TECNO MOBILE LIMITED

Product Similarity Declaration

We, TECNO MOBILE LIMITED, hereby declare that we have a product named as Mobile Phone, Model: KH6, FCC ID: 2ADYY-KH6, has two versions, Hardware version: V1.0 and Hardware version: V1.2, the PCB of those two versions has partial minor circuitry of non-transmitter portions was difference, which were tested by Shenzhen Accurate Technology Co., Ltd., The differences between the two versions are as follows:

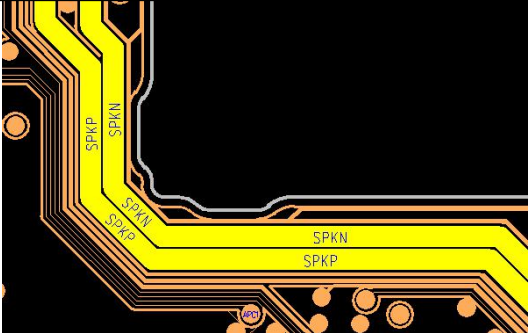
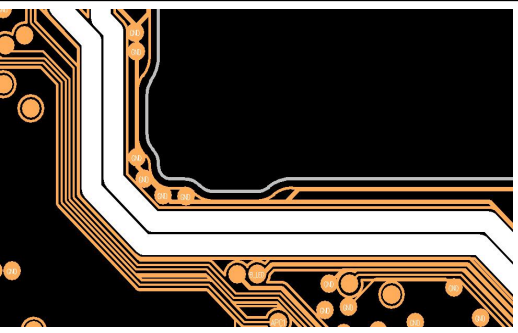
Hardware version	V1.0	V1.2
PCB change : Adjust the audio route to the board, and adjust the peripheral route		
PCB change : adjust optimization of linear

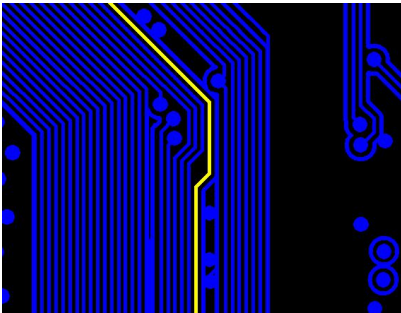
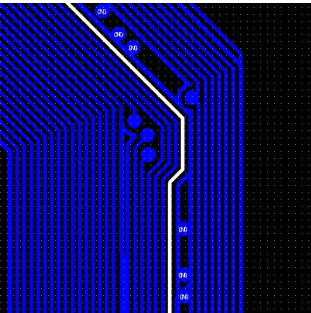
<p>PCB change : adjust isolate cabling and add the mainboard identifier</p>		
<p>PCB change : ADD R2267,C2256 and The wiring and component position are adjusted accordingly</p>		
<p>SCH change: Add R2267,C2256</p>		
<p>SCH change: Add BGND2</p>		
<p>PCB change : Change audio PA peripheral circuit placement and wiring, delete R115</p>

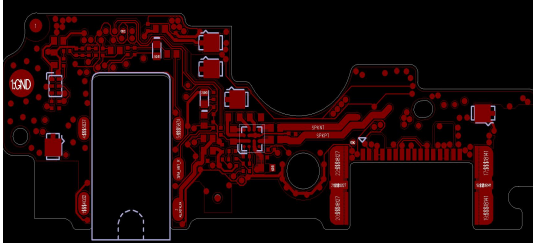
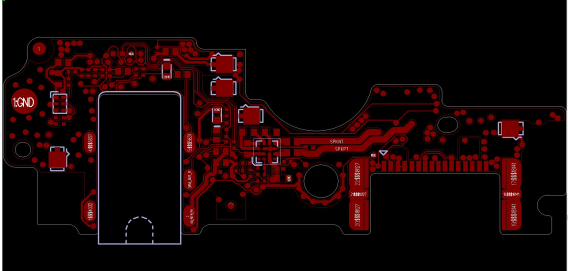
<p>PCB change : Change MIC peripheral circuit placement and wiring ,and add TAG</p>		
<p>PCB change : delete R115</p>		
<p>PCB change : Add identifier</p>
